# ADDENDUM NO. 05 – PORTAGE PUBLIC SCHOOLS – CENTRAL ELEMENTARY SCHOOL BP 4: CONSTRUCTION

# ADDENDUM NO. 5 (BP4)

PROJECT: Central Elementary School Bid Package 4: Construction

ARCHITECT'S PROJECT NO.: 21-237.10

DATE

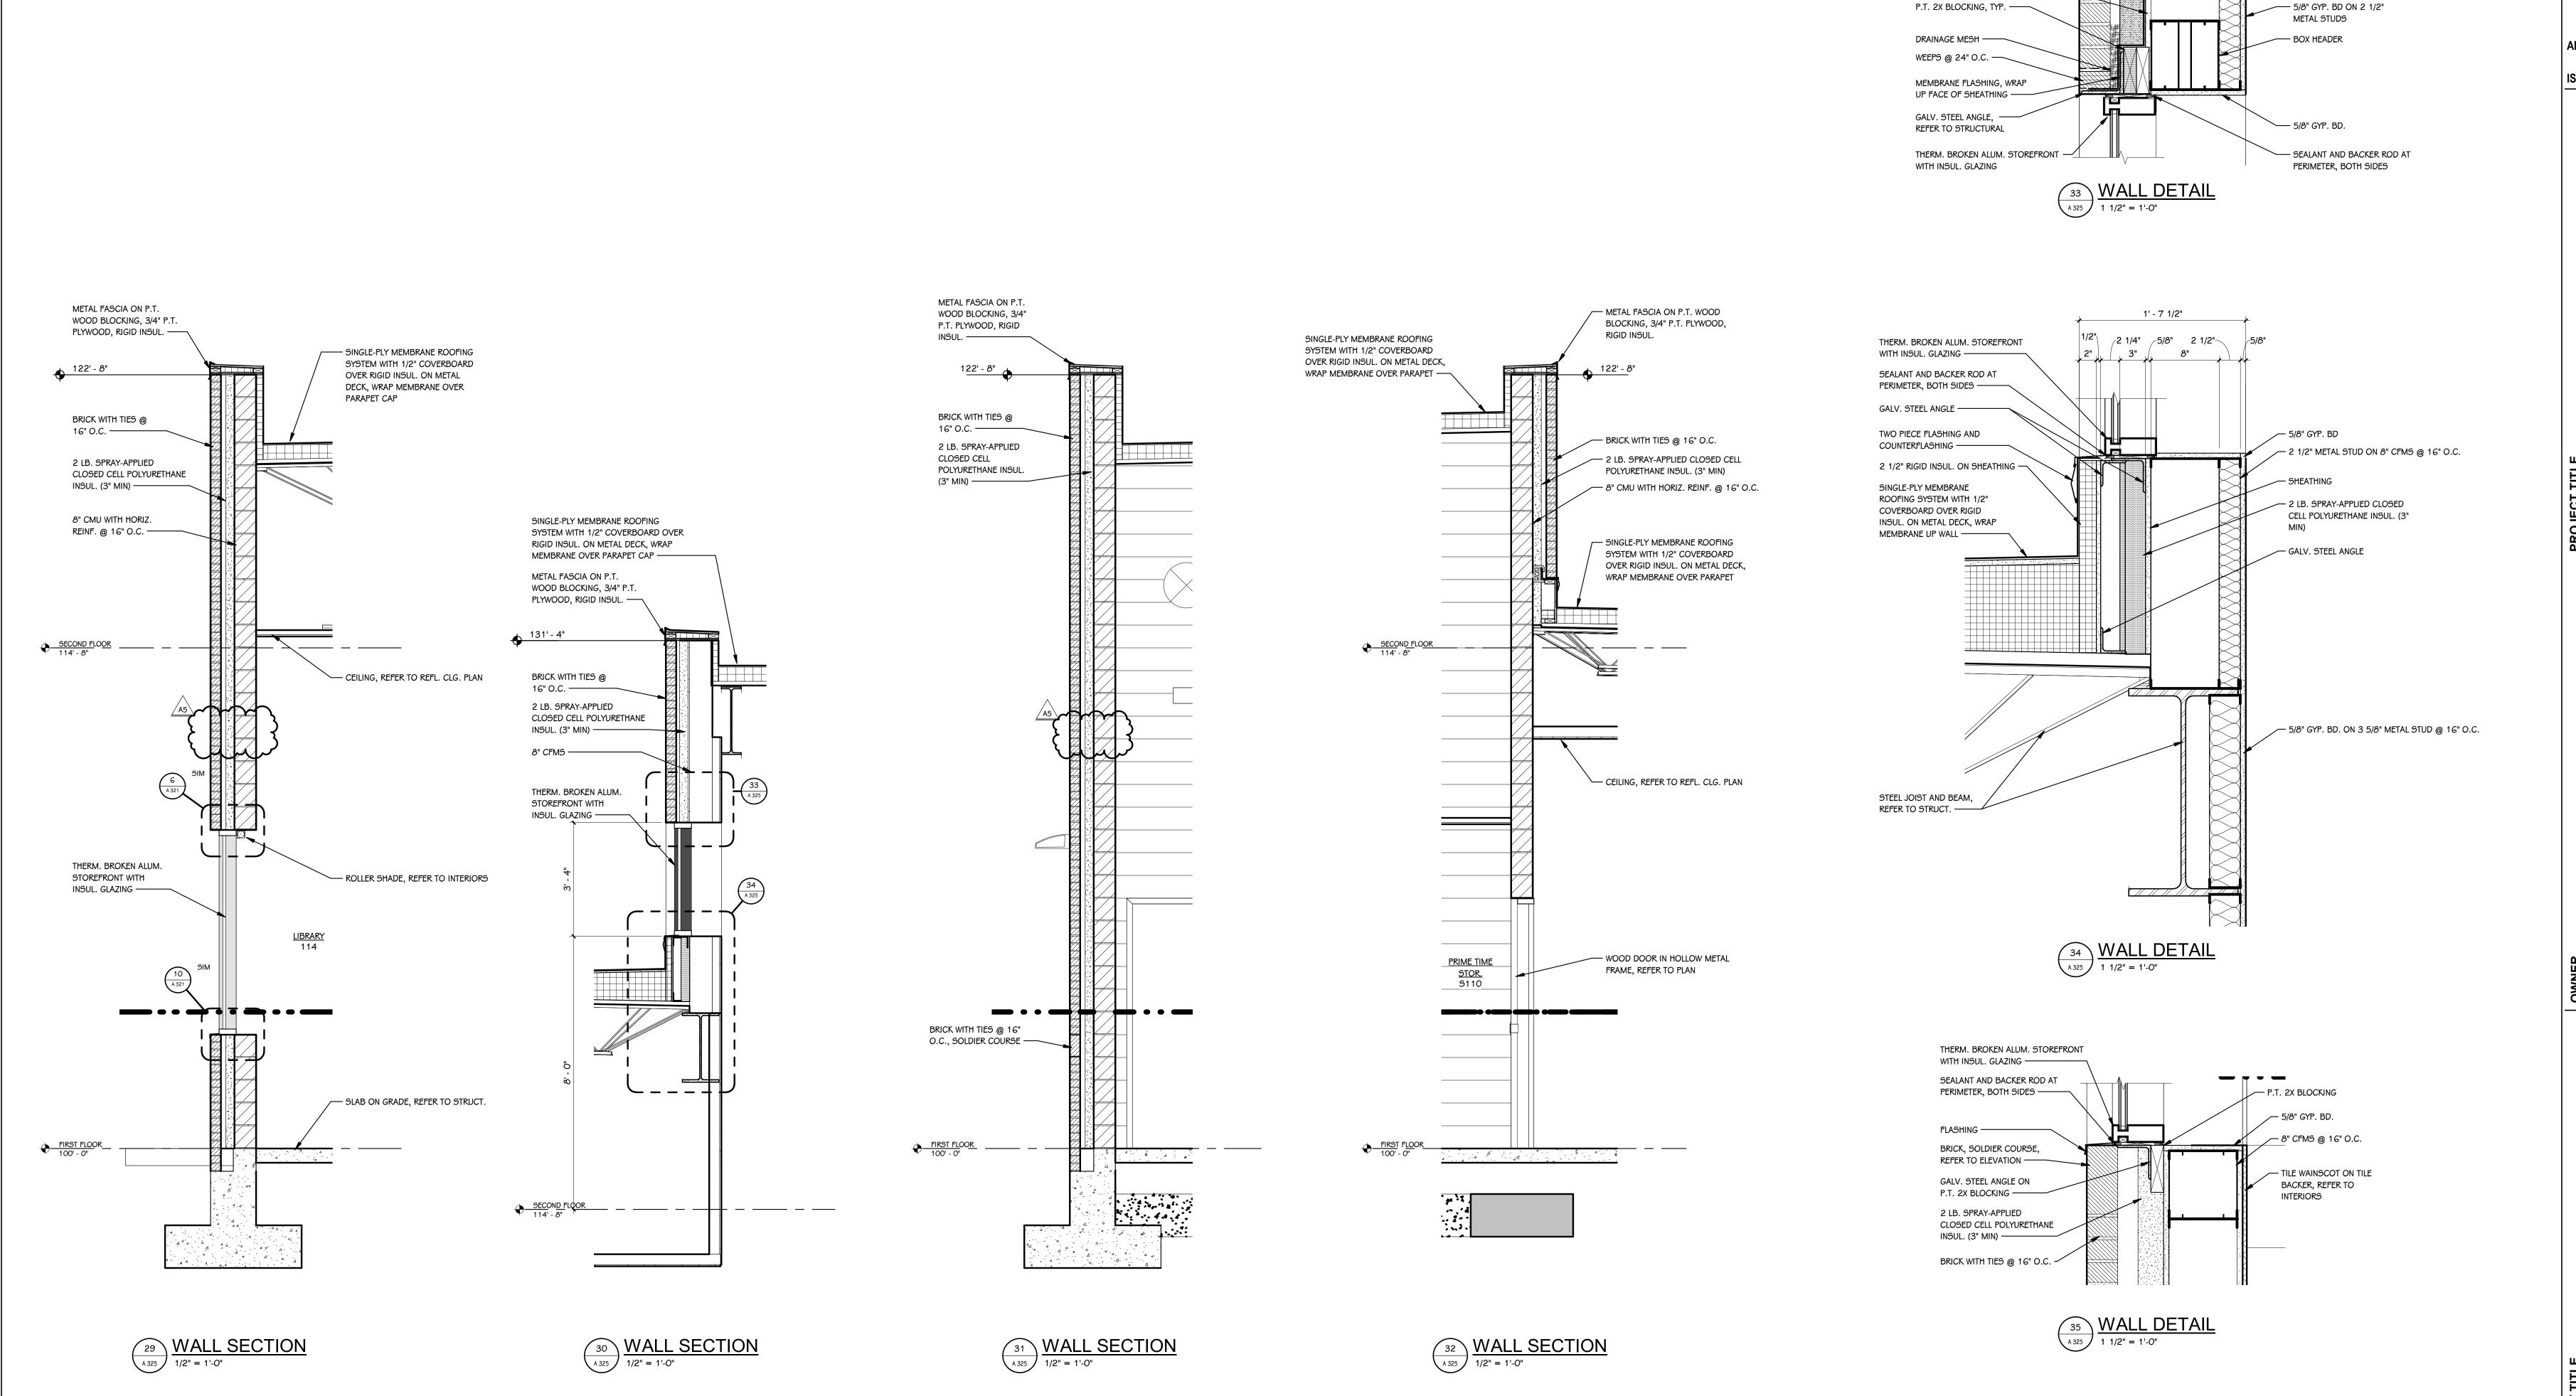
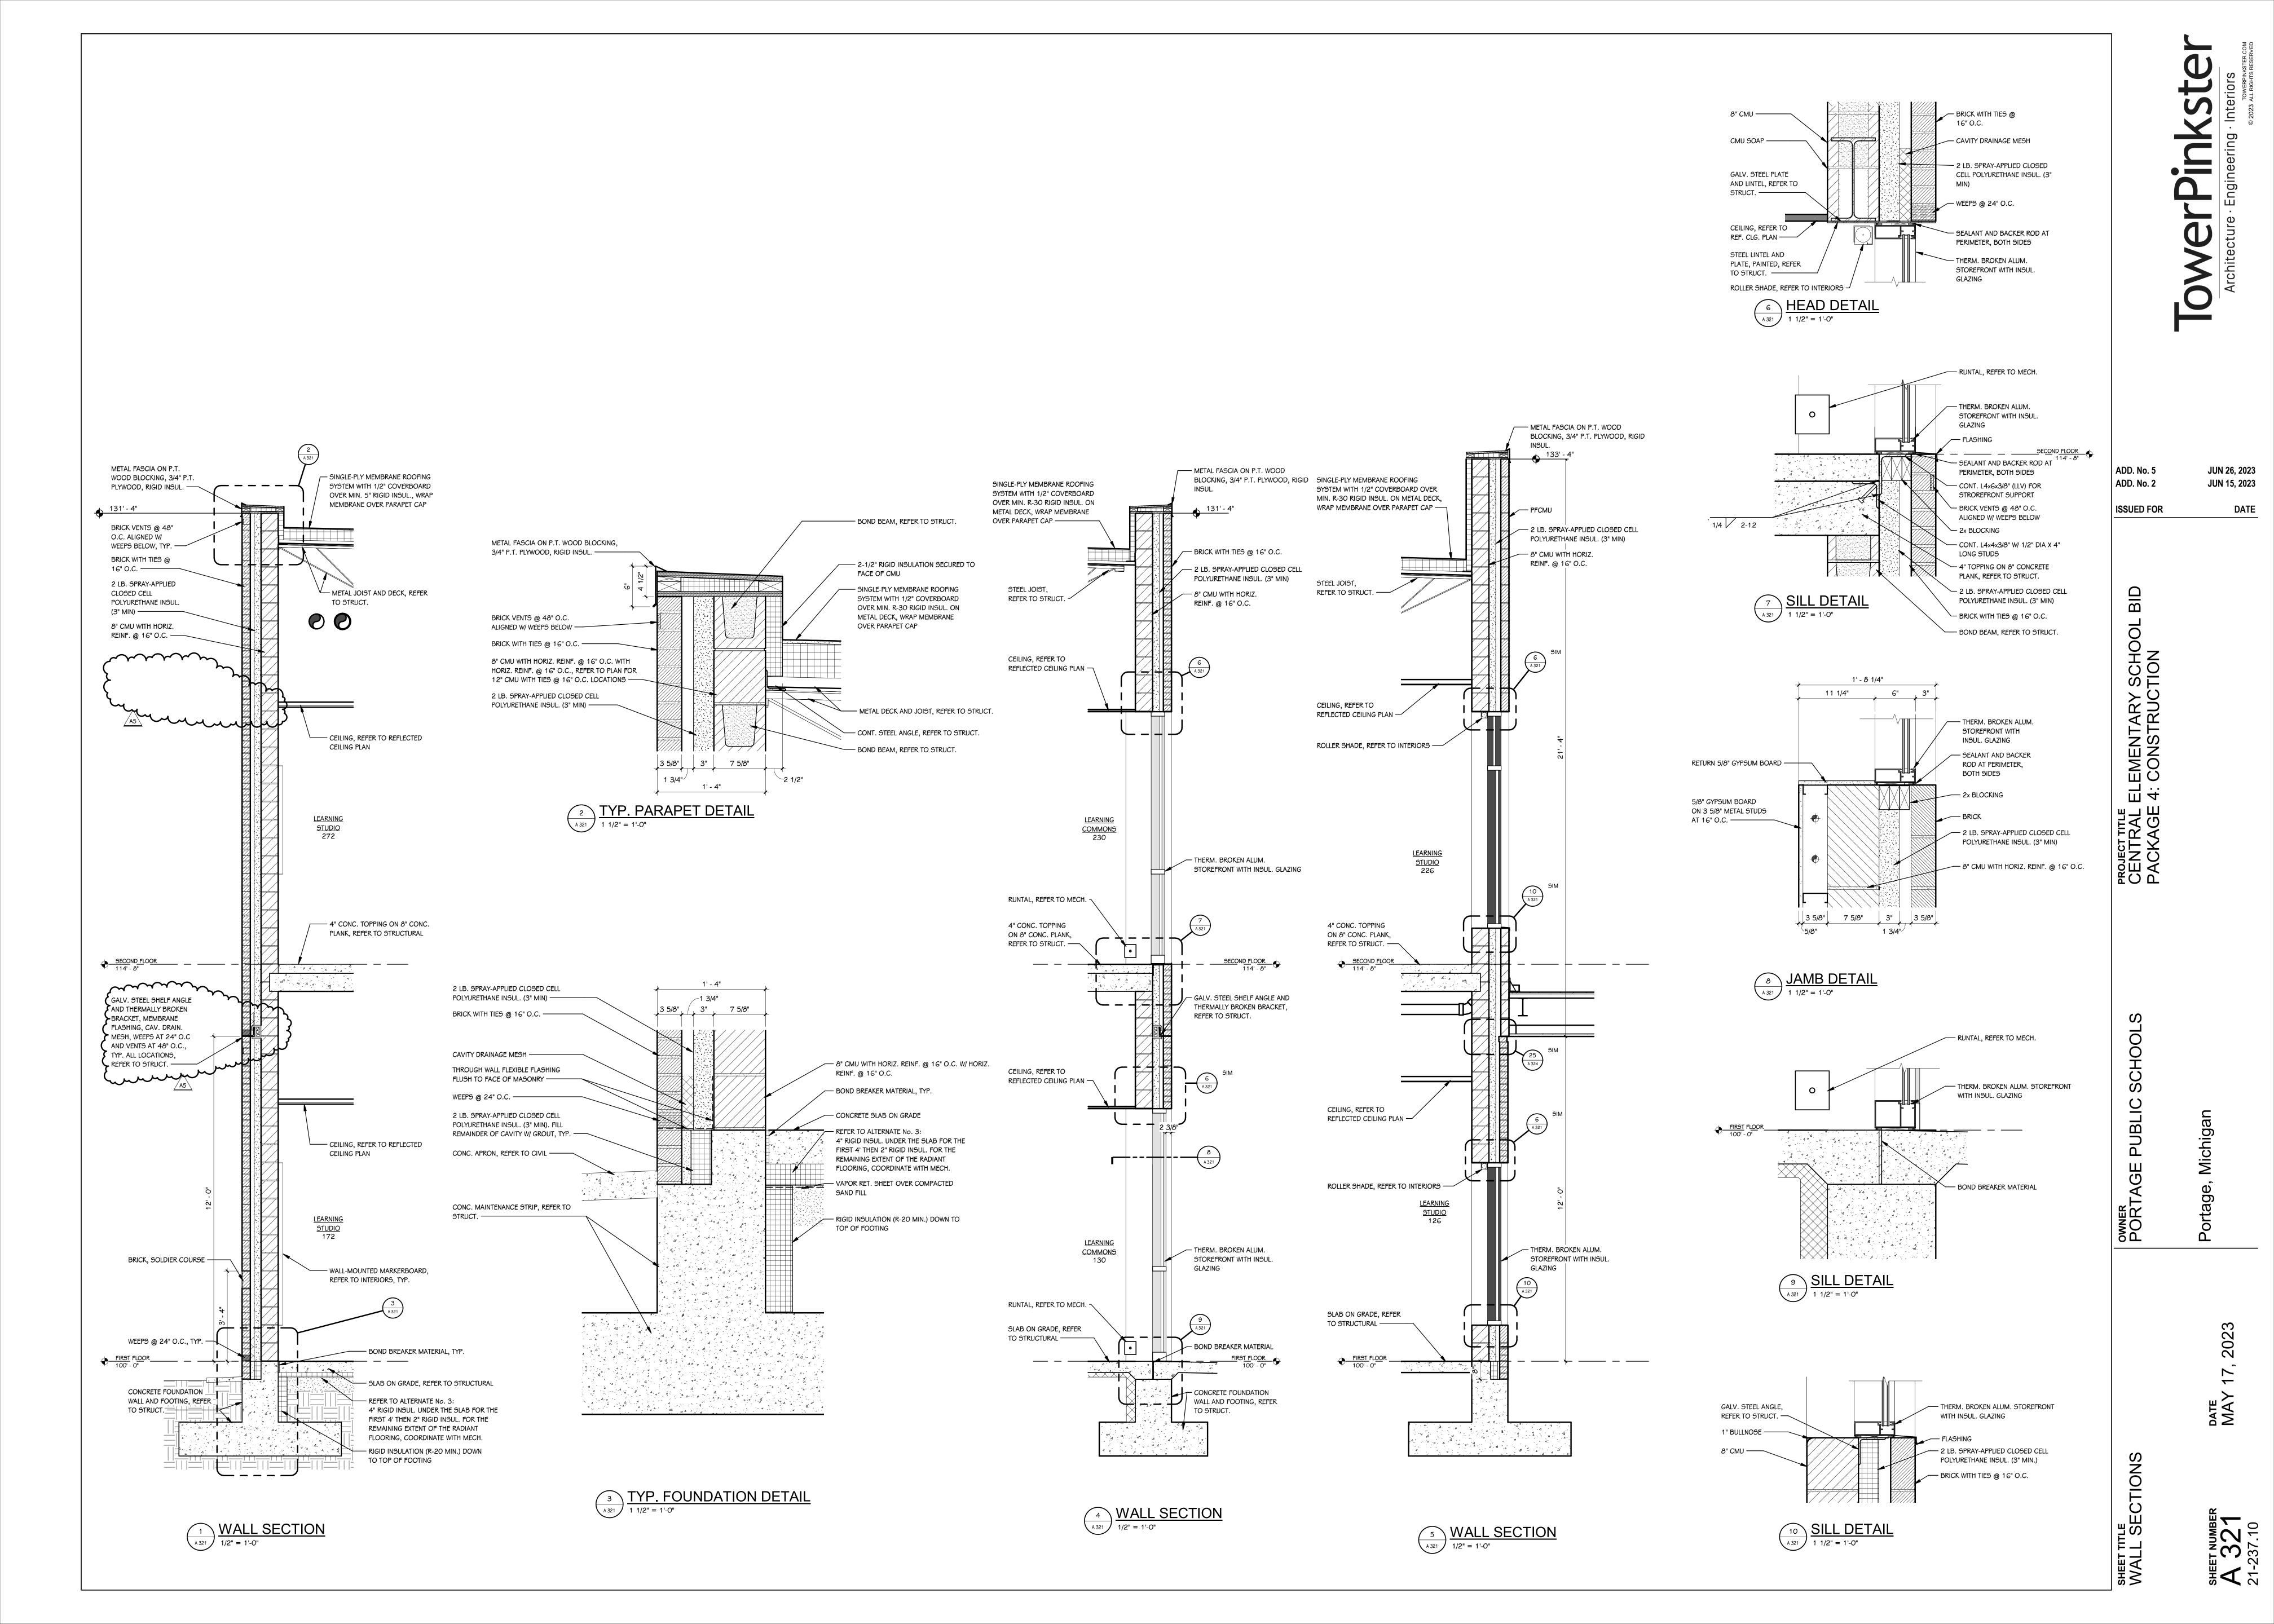
#### ADD-5 Item No. D-7 - Thermal Brackets at Veneer Bearing

Fero Fast thermal bracket detail updated. Thickness of continuous shelf angle is revised.

Revised wall sections to remove shelf angle and bracket in alignment with 2<sup>nd</sup> floor openings. Revised shelf angle and bracket note, added typical note to 1/A321, provide membrane flashing, cavity drainage mesh, weeps and vents at shelf angle [12'-0"h locations].
